**RFT# 4264
Boiler Replacement, Gym Heat Pumps,
and Controls Upgrades
Harrietsfield Elementary School
Addendum #1**

To: All Bidders
Date: May 26, 2025
From: Nancy Rideout, Purchasing Manager
Office: (902) 464-2000 ext. 2222
Email: nrideout@hrce.ca

ASPHALT SURFACE
SCALE: N.T.S.

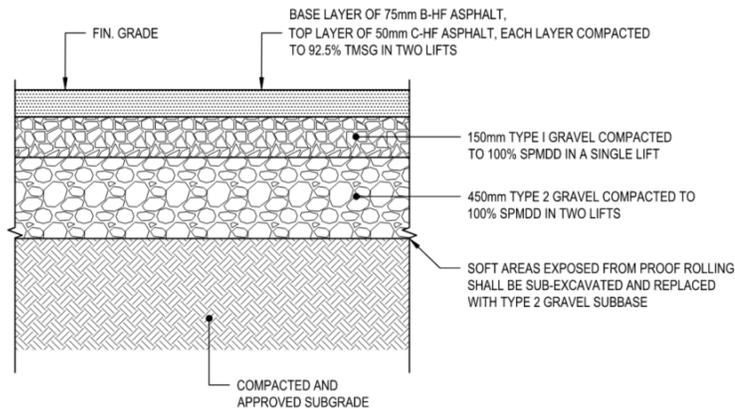
3) Reference Specification Section 00 00 15 'Description of Work & List of Drawings', and complete the following edits:

- a) Add new Paragraph and sub-paragraphs as follows:
- 1.1.4. Optional Scope 3: Reconstruction of Bus Loop:
 - 1.1.4.1 General extents of the scope of work to match the extent of Optional price 2, as represented on drawing M101
 - 1.1.4.2 Provide for removal of the existing asphalt and sub-base material as needed to restore to grade level with the newly specified methodology.
 - 1.1.4.3 Provide for removal of the existing curbs within the indicated area.
 - 1.1.4.4 Provide for installation of new concrete curb and gutter along the reconstructed driveway, constructed to HRM standard detail FRM-53.
 - 1.1.4.5 Provide for reconstruction of the parking lot, driveway, and bus loop as indicated in the detail below:

- NOTES:**
1. THICKNESSES SHOWN ARE MINIMUM. IF EXISTING ROAD STRUCTURE EXCEEDS THESE, MATCH EXISTING.
 2. SUBGRADE TO BE INSPECTED AND APPROVED BY A GEOTECHNICAL ENGINEER.
